PRELIMINARY APPROVAL DEVELOPMENT PLAN

22-ZONE-0097, WM# 12465

1140 Cherokee Road & 2013 Patterson Avenue
Louisville, Kentucky 40204
Owner:
1140 Cherokee Road LLC
946 Goss Avenue, Apt. 6101
Louisville, Kentucky 40217

Rezonng Application
Job No: 22318.000
Date: July 1, 2022
Scale: 1" = 20'
Drawn By: AWB
Checked By: AWB
Drawing Title: 1140 Cherokee Road Resonng Application Plan
Drawing No: 1 of 1

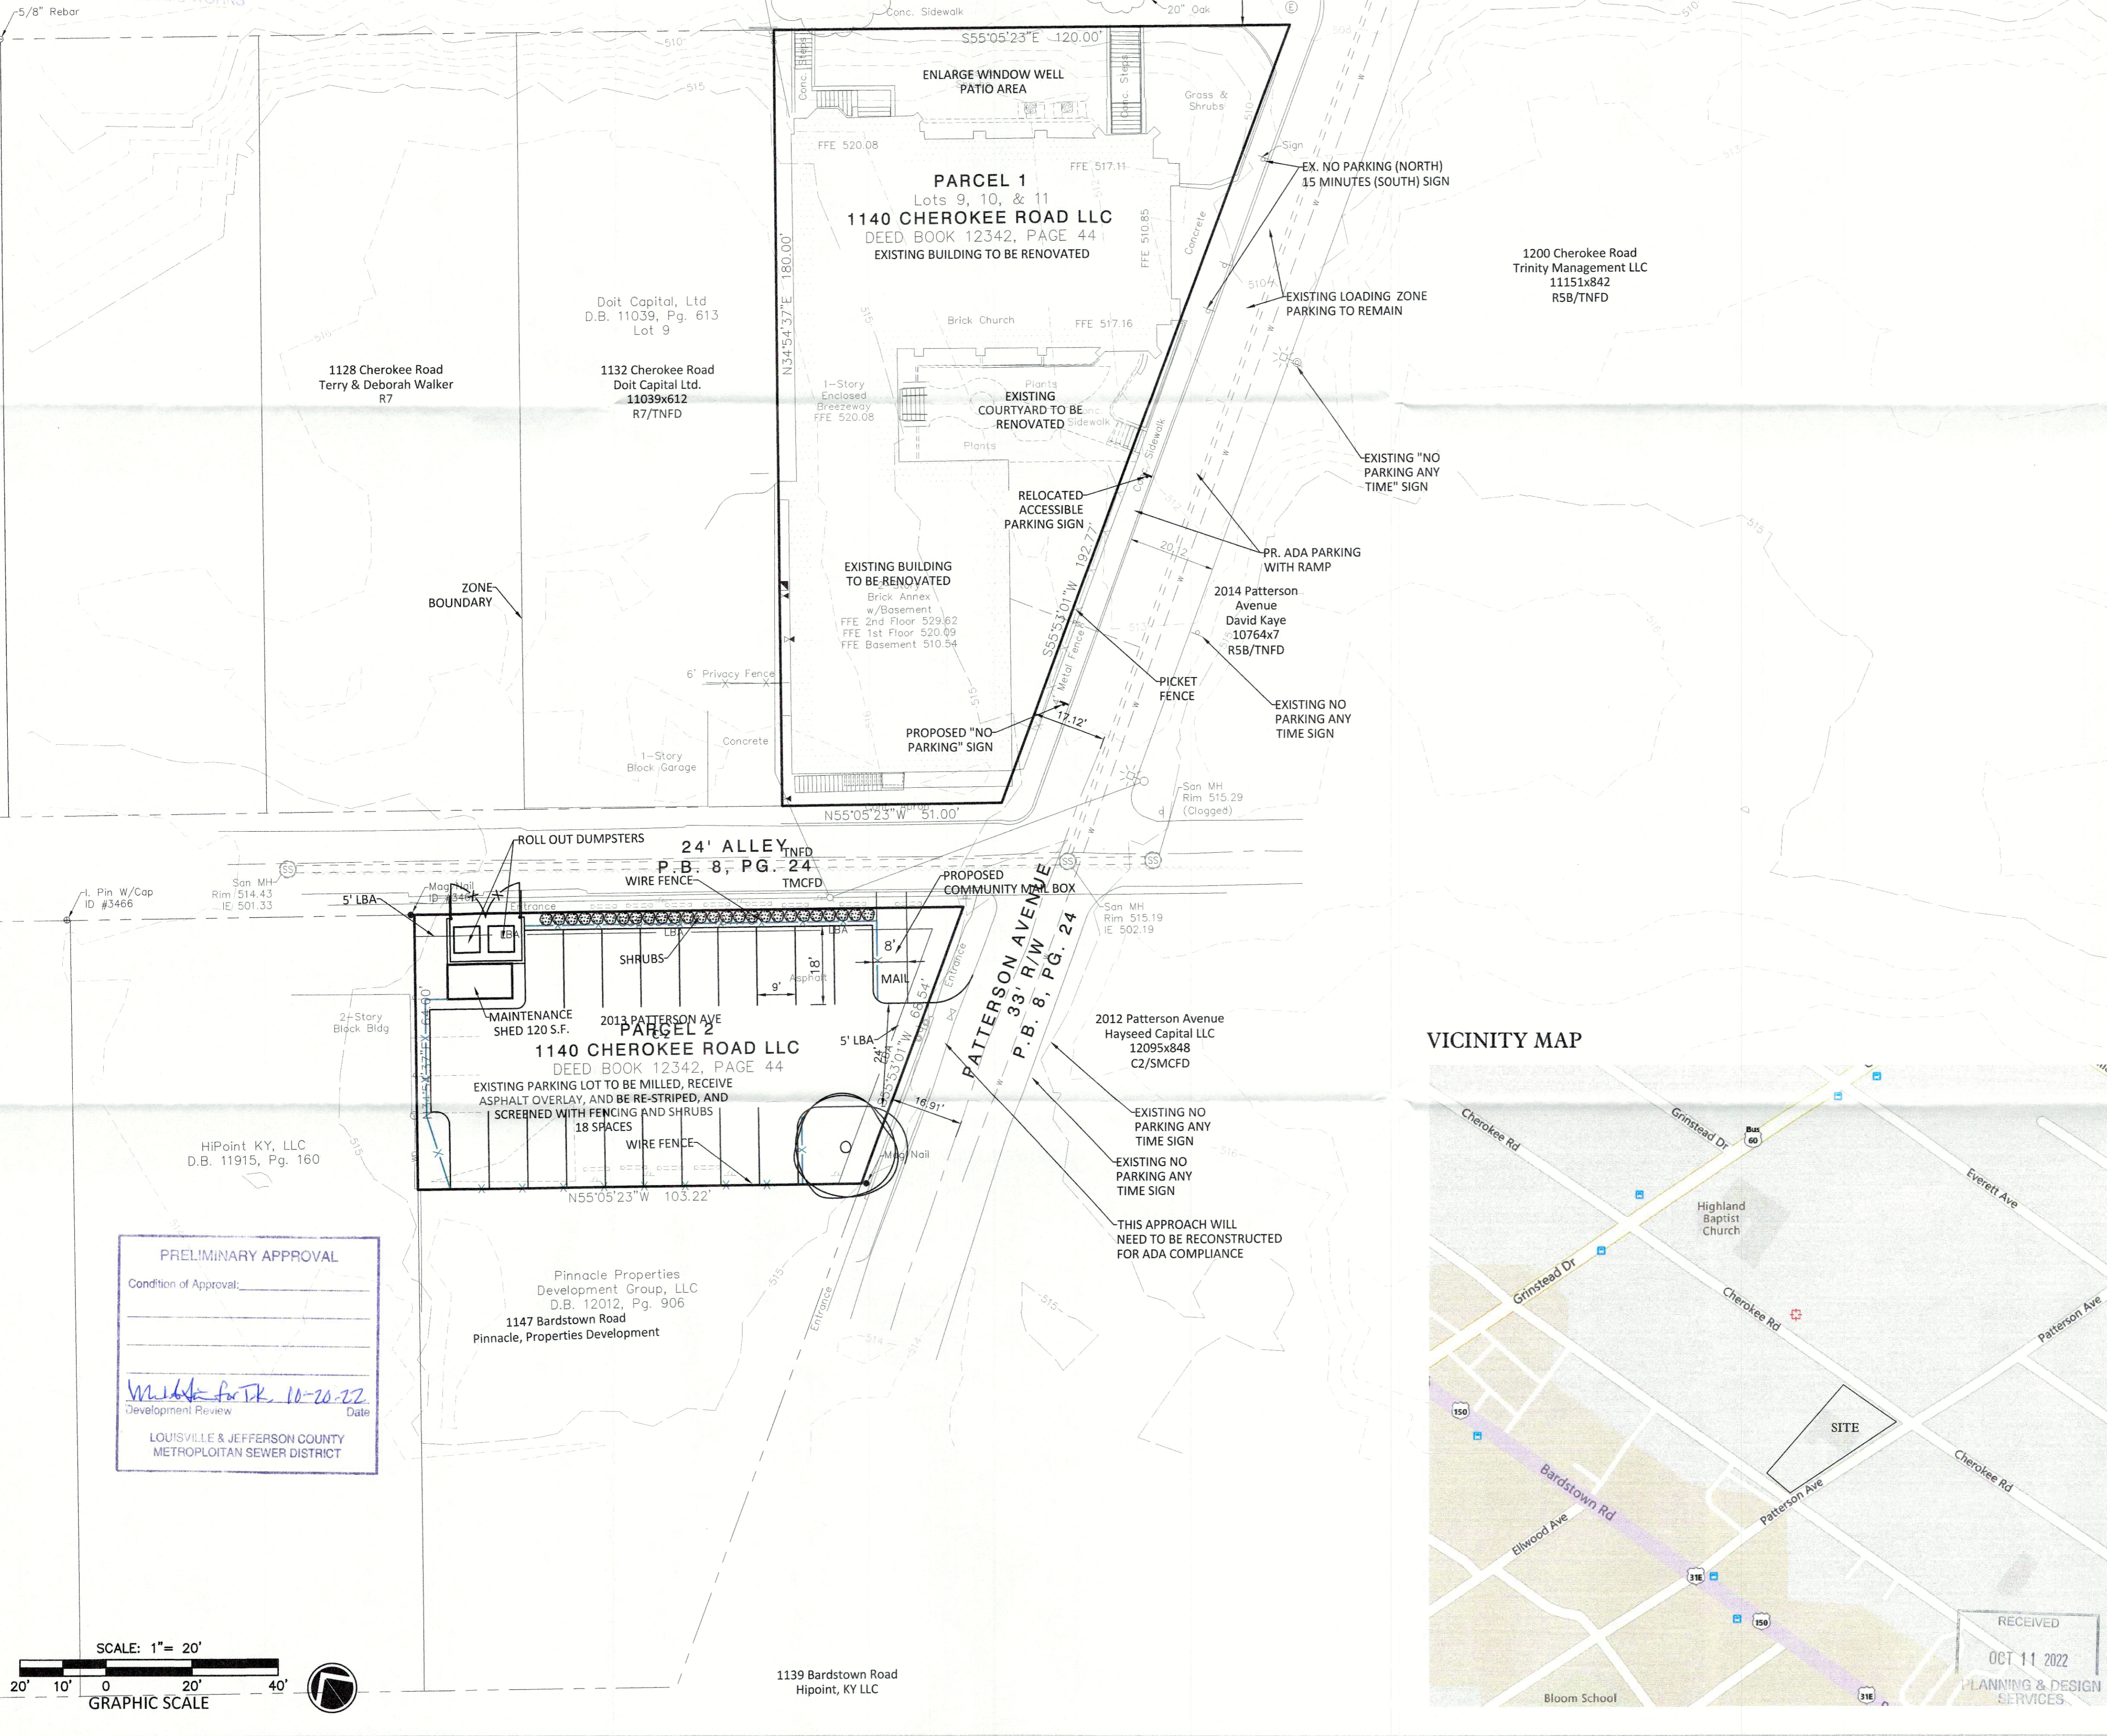
EXISTING ACCESSIBLE PARKING
SIGN TO BE RELOCATED TO AREA
MARKED "PR. ADA PARKING WITH RAMP"
PRIOR TO CERTIFICATE OF OCCUPANCY
